**MINUTES
PLANNING COMMISSION
September 10, 2025**

The Planning Commission of the Parish of Ascension held a Public Meeting on Wednesday, September 10, 2025, at 6:00 p.m. at the Ascension Parish Courthouse, 607 E. Worthey Road, Council Chambers – 1st Floor, Gonzales, Louisiana in a regular session convened.

Subject: Recommended revisions to Appendix V-Drainage.

Exhibit ‘B’

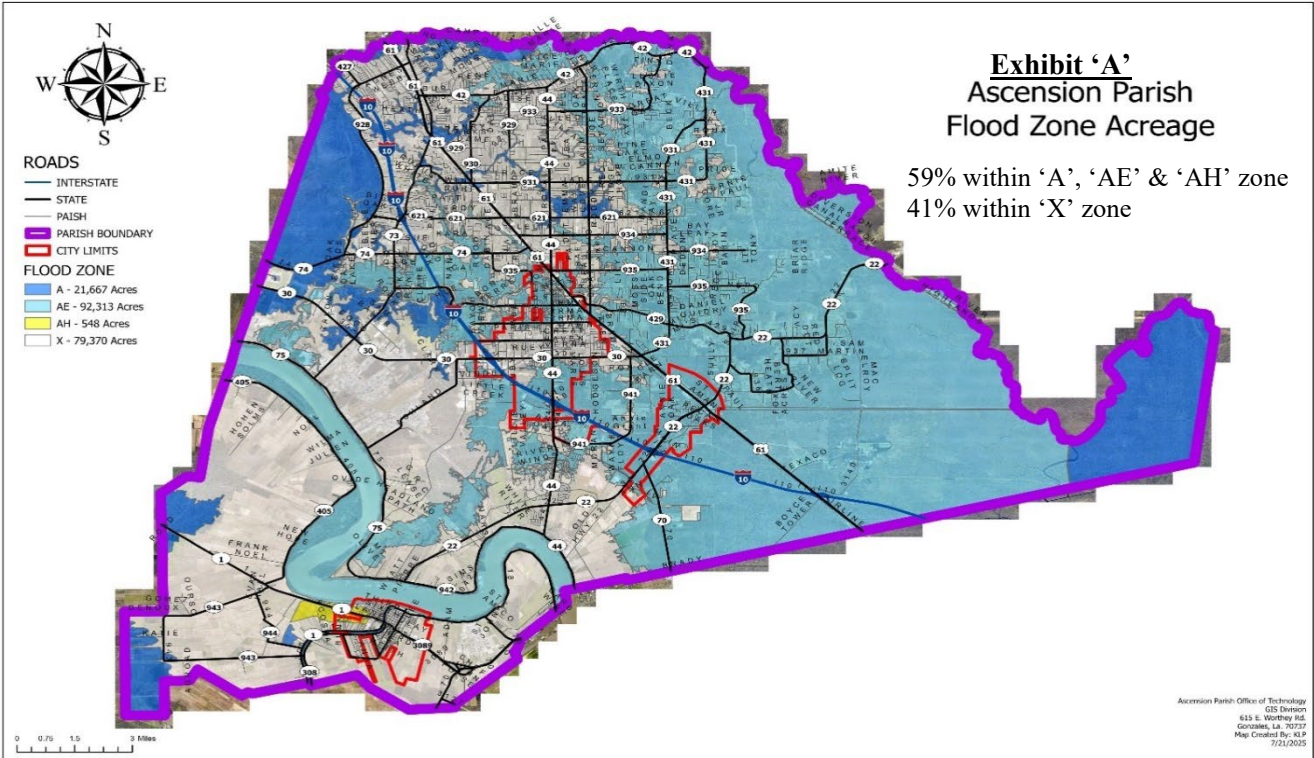
- A. This ordinance shall apply to any proposed development within the parish with the exception of properties within flood zone ‘X’ as per Section 17-505.A.2. Compaction tests shall be required for any property/dwelling meeting the conditions of 17-507.B.4. ~~regardless of flood zone designation.~~ Development shall be defined as the division of a parcel of land into two or more parcels with associated earthwork, the construction of a new major or minor subdivision, multi-residential or commercial building or structure, the relocation or enlargement of any commercial building or structure, the construction of parking surfaces for commercial developments or the clearing, grading, filling, or movement of land. The following shall be exempt from the requirements of this ordinance as described below:

By removing requirements within the FEMA flood zone ‘X’, it will prevent those who are not in a flood zone from expending funds or wasting permitting time to provide documents that are generally unnecessary. Approximately 41% of the parish is in zone ‘X’ as shown in Exhibit ‘A’. This is especially cumbersome for those in the ‘X’ zone who wish to install generators or are above the minimum required elevation. Additionally, on the West Bank, the levee creates unusually high Base Flood Elevations requiring waivers on most properties within the ‘X’ zone. The ‘X’ zone covers between 90%-95% of the West Bank, which this change would alleviate, as evidenced by Exhibit ‘B’.

Exhibit ‘D’

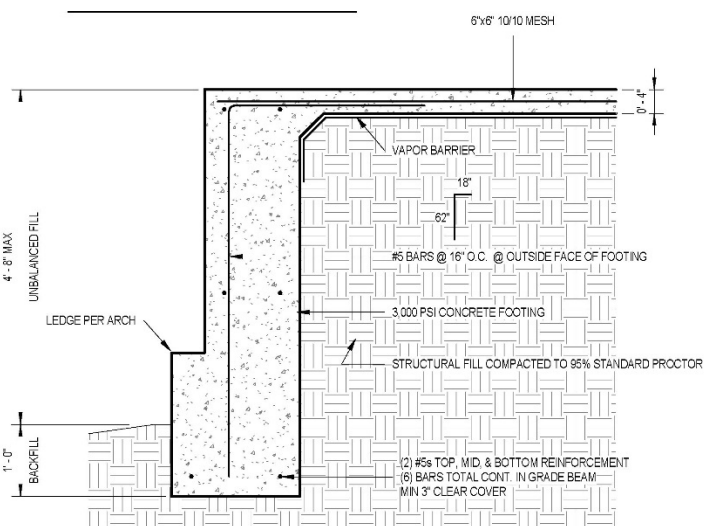
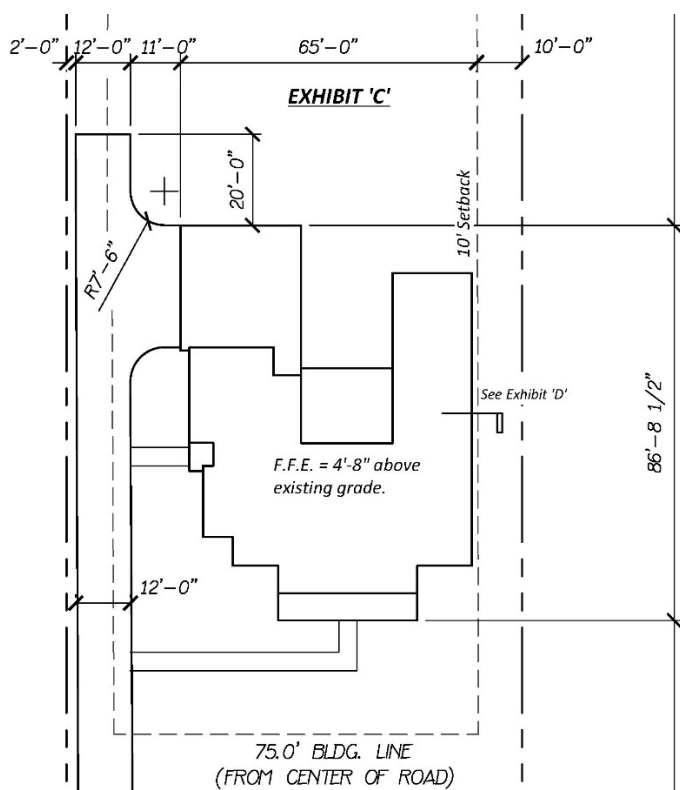
2. Side slope of fill under the structure(s) shall not be steeper than a three-foot horizontal to a one-foot vertical slope.
3. Fill shall not be placed within any setback line as per Appendix I – Zoning Tables. Should fill be placed closer than 10' from any property line, it must be contained within the foundation of the building/structure. closer than ten feet to any property line, regardless of setbacks.

3. This allows the use of a property's complete setback, provided all fill within 10' of the property line is contained in the foundation. Previously, if a property had a 5' setback, a landowner would be forced to increase that setback if there was fill to be placed. The parish does not desire to force individual landowners to lose the use of a portion of their property by conflicting rules.

4. Exhibit 'C' below, is a plan showing the slab against a 10' setback line and Exhibit 'D' shows the drop brick ledge that allows almost 5' of fill to be placed within the foundation. Properties with a 5' setback would be similarly affected.

Exhibit ‘E’

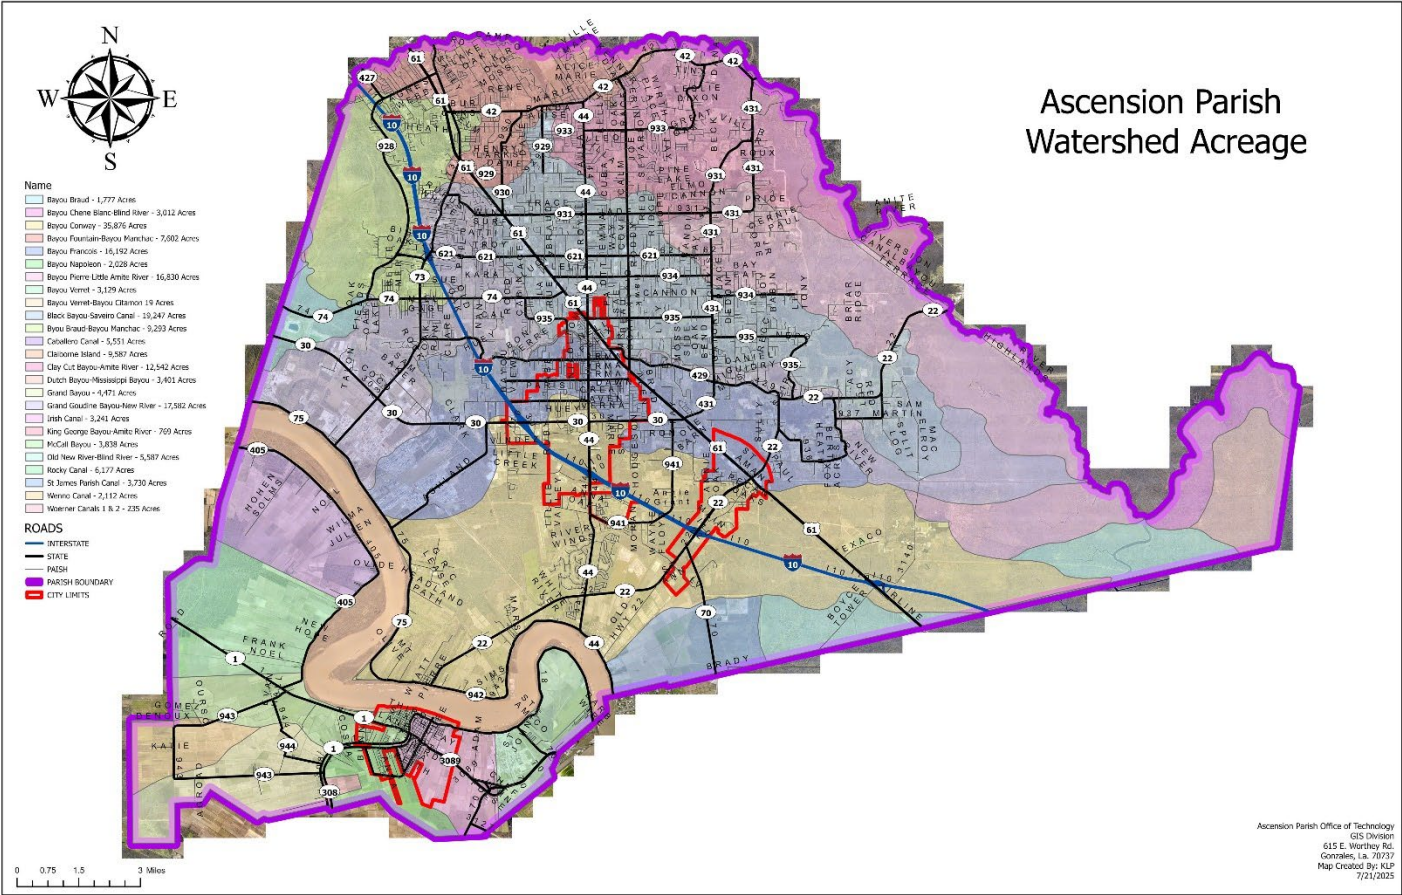
1. This rule previously went off topographical watersheds (Exhibit ‘E’). However, since mechanical pumps empty water from multiple watersheds throughout a drainage basin (Exhibit ‘F’), it is logical to use the drainage basins as the new limit for each mitigation bank located within that basin.
2. Removing the limiting factor of +/- 1’ between the off-site source and the developed source incentivizes individuals who may be thinking of providing engineered fill mitigation from an off-site source to do so as their credits will be valid over a greater area than was previously allowed. This will also provide a more competitive pricing structure for mitigation credits within a drainage basin.

The exhibit below highlights the topographical watersheds on the East and West Bank of the Parish. Taking into account that there are no Drainage Basins on the West Bank, there are 14 watersheds on the East Bank with an average size of 10,960 acres.

Exhibit ‘F’

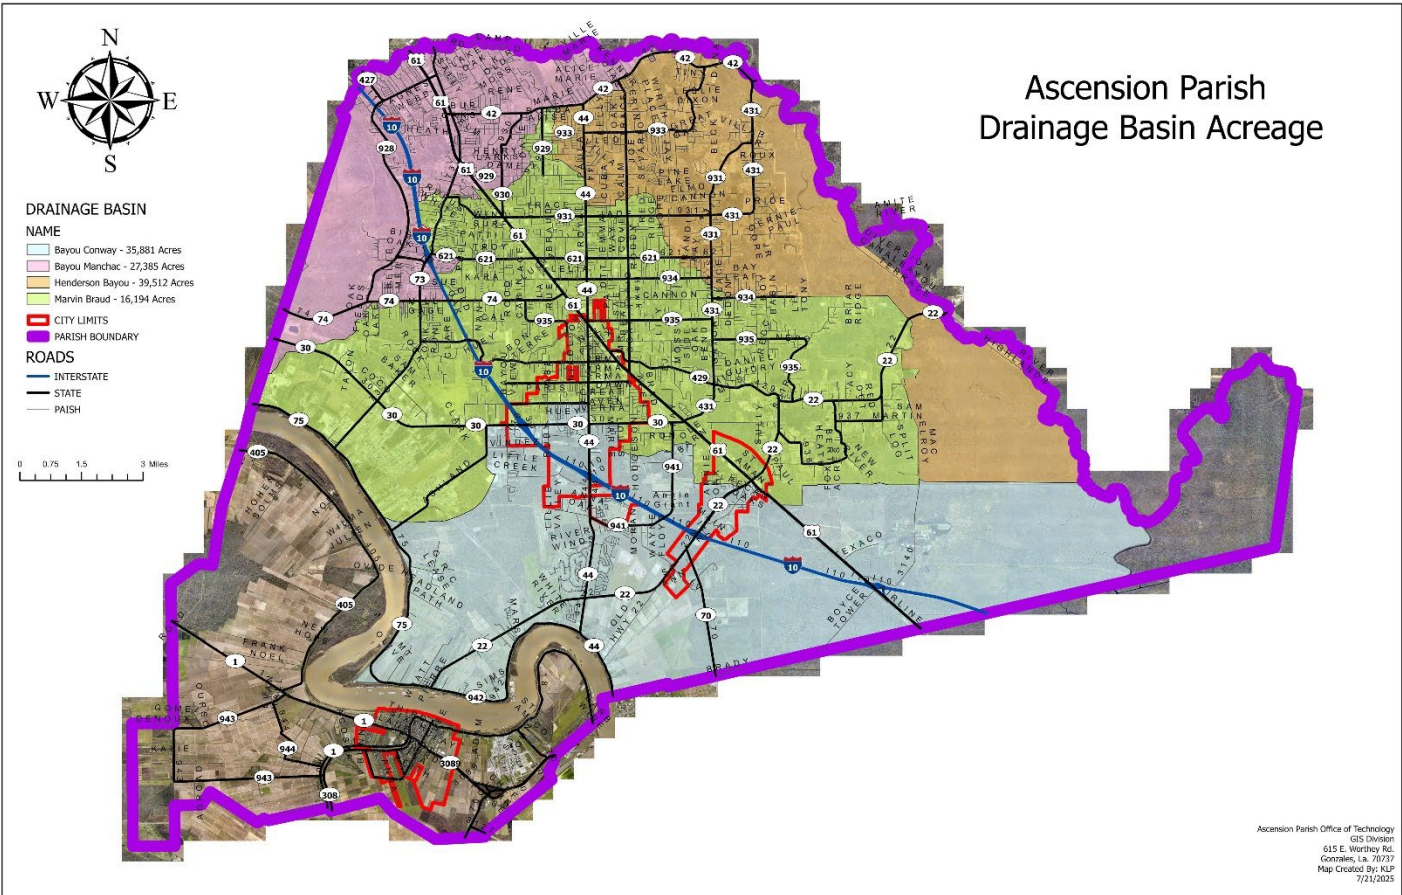
The exhibit below highlights the pump station drainage basins on the East Bank of the Parish. There are 4 drainage basins on the East Bank with an average size of 29,743 acres. This is almost 3 times the average size of the topographical watersheds.
